**FINAL DRAINAGE REPORT
FOR
PLATTE SELF STORAGE
COLORADO SPRINGS, COLORADO**

NOVEMBER 2024

TNE Job No. 2419.00
County Job No. PPR2418

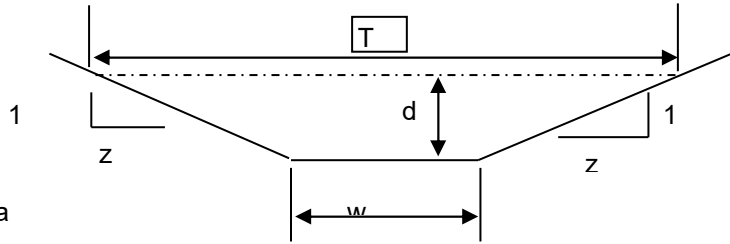
Provide a more specific design as it appears velocity could be over allowable.

Figure 13-12c. Emergency Spillway Protection

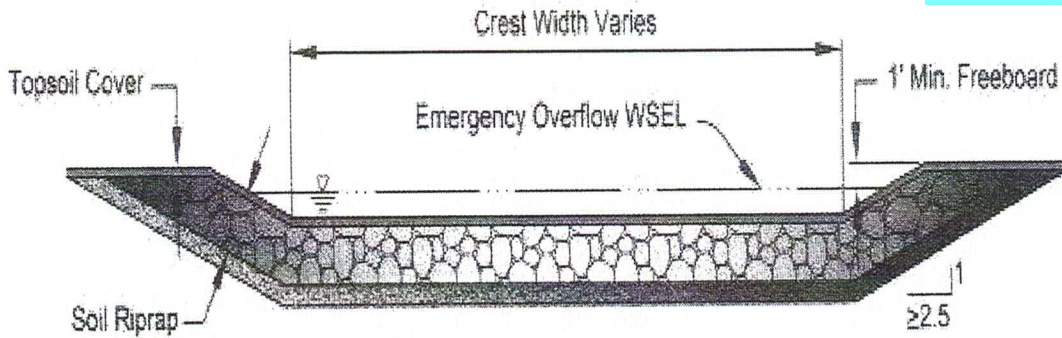
Drainage Map has this swale called out as grass. Please verify and update accordingly as to if it is riprap or grass.

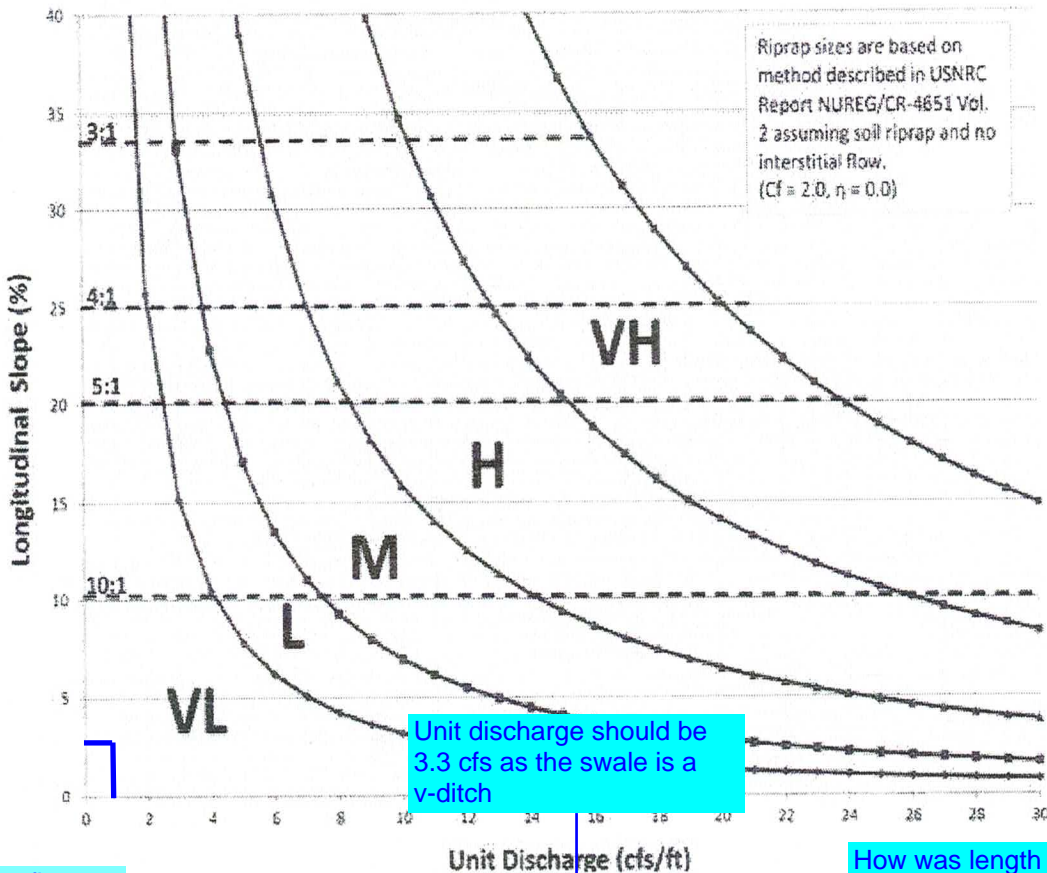
This graph is for the overflow spillways at a pond. Suggest using a riprap rundown spreadsheet instead of this one.

Pipe ID: **18" RCP Culvert**

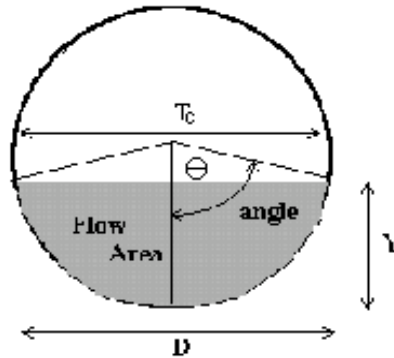
Include label to indicate which culvert this is.

EXISTING DRAINAGE MAP

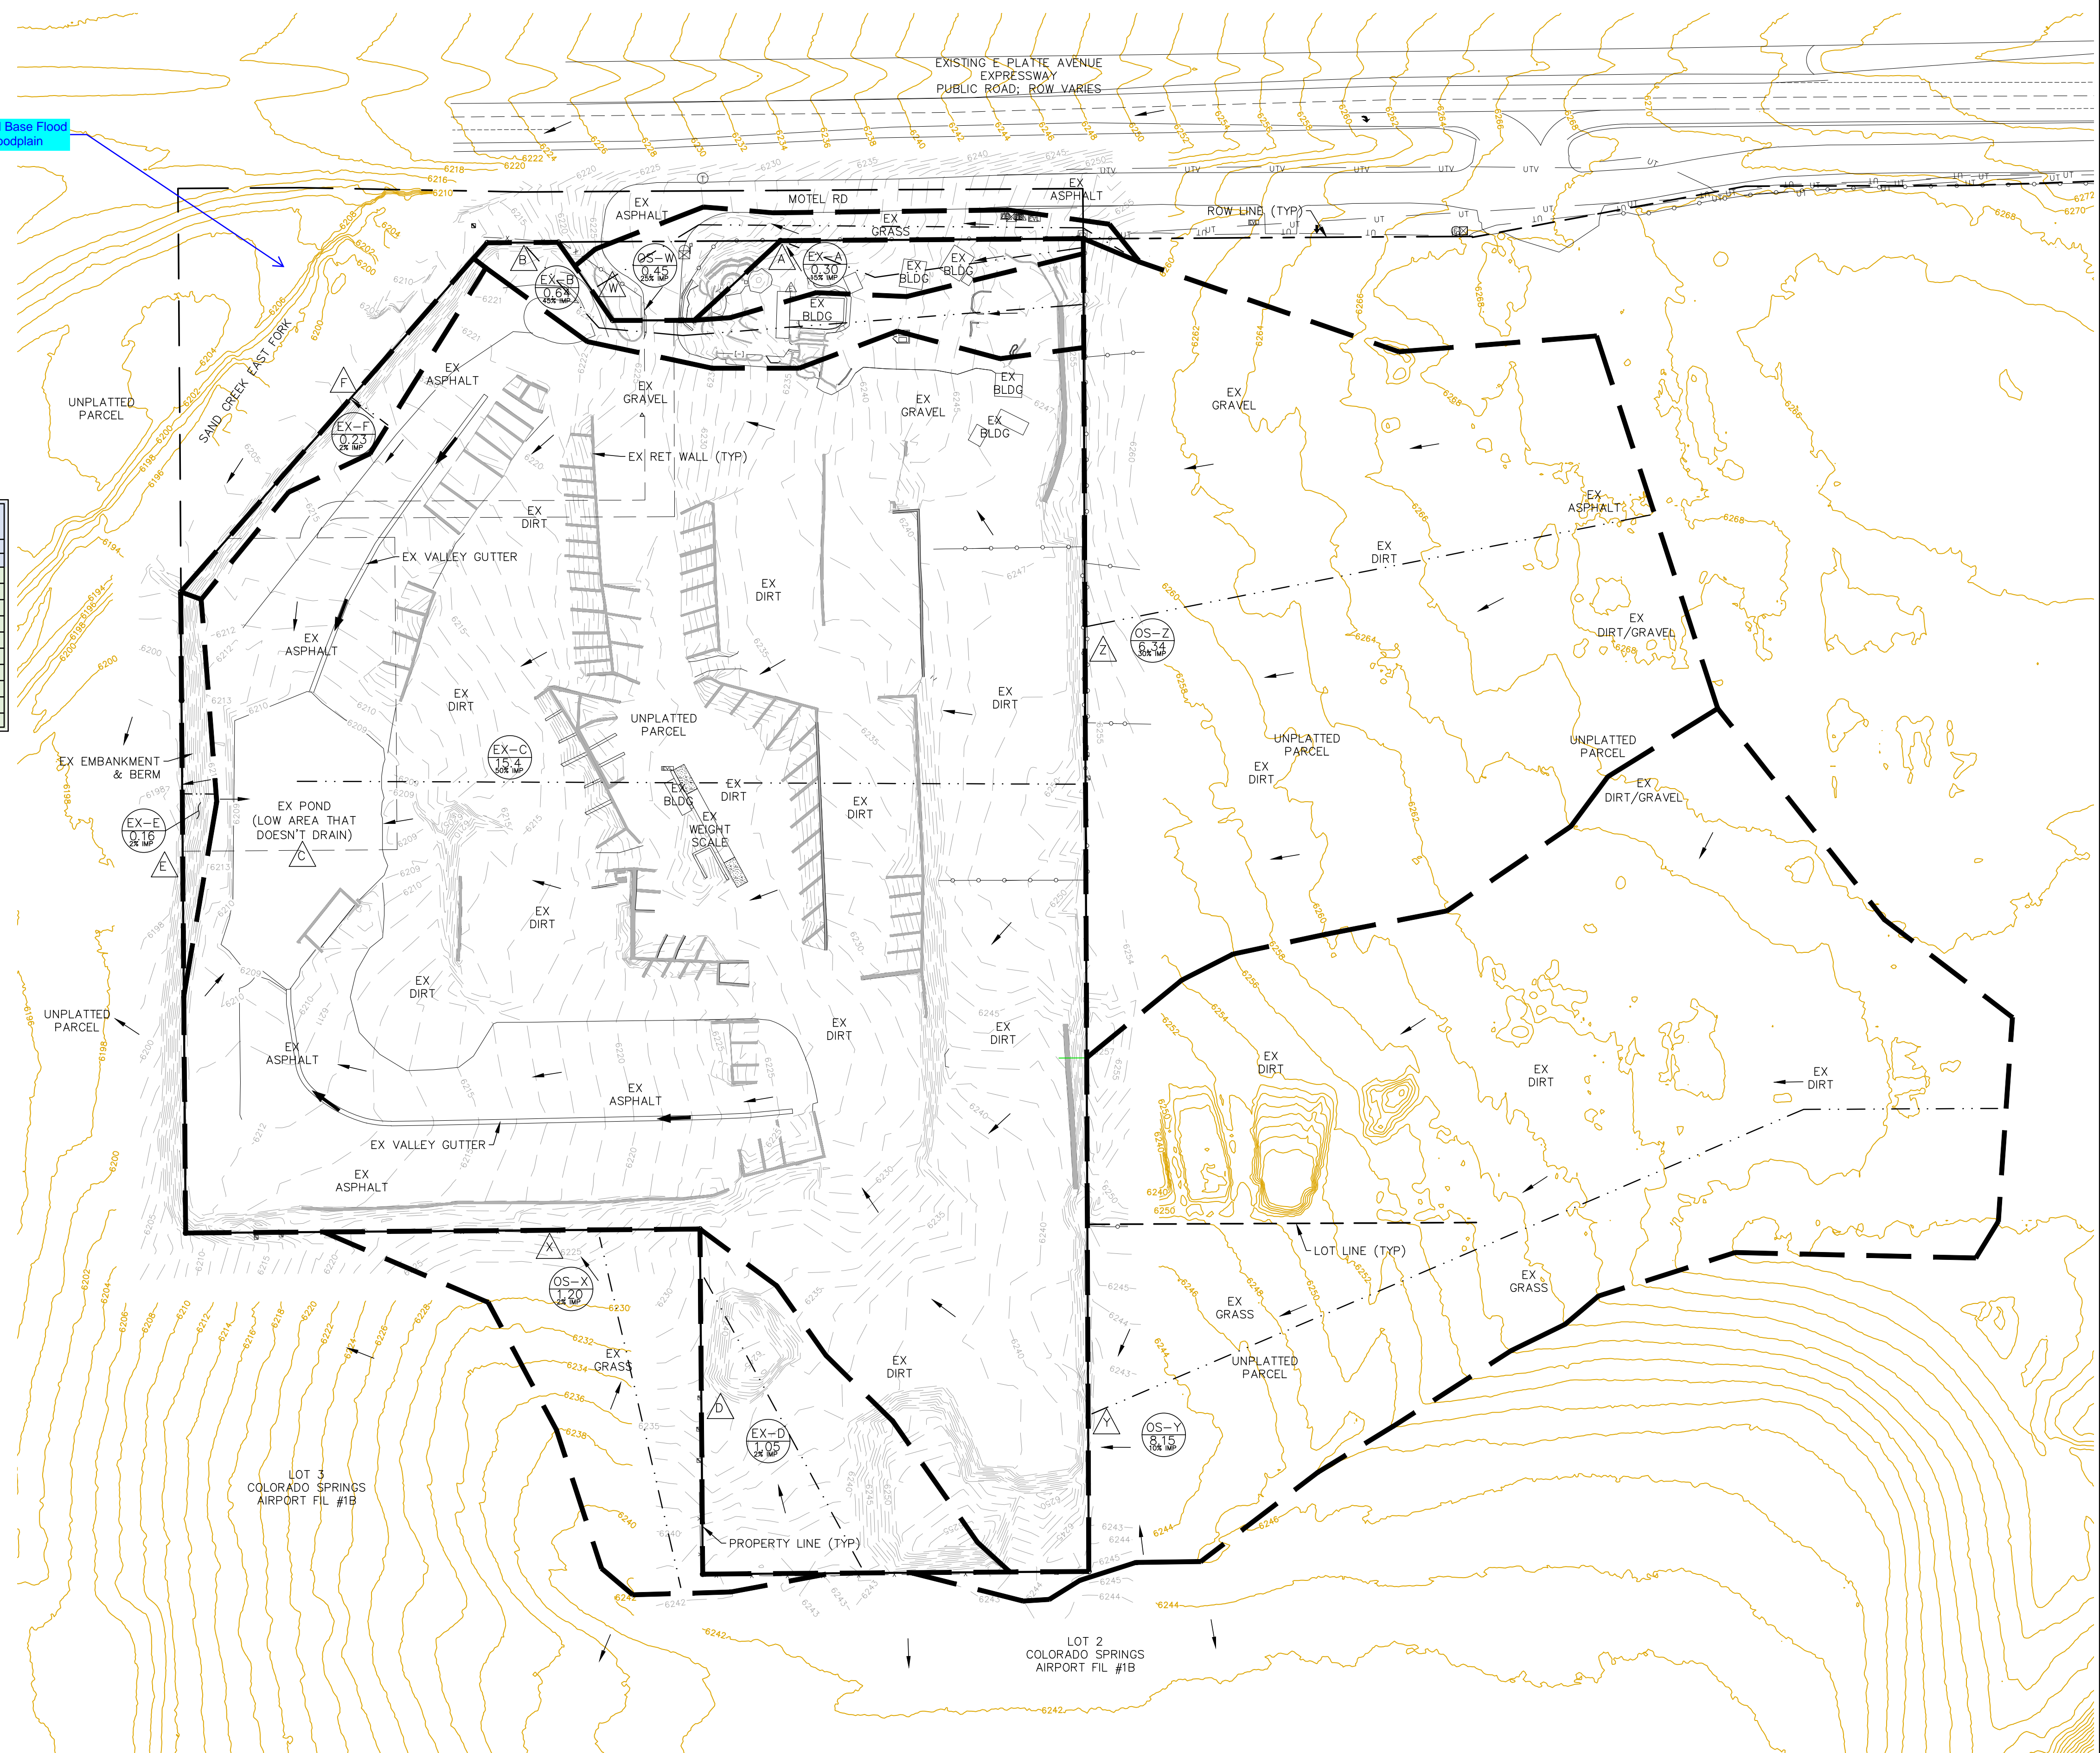
Show and label Base Flood Elevations in floodplain
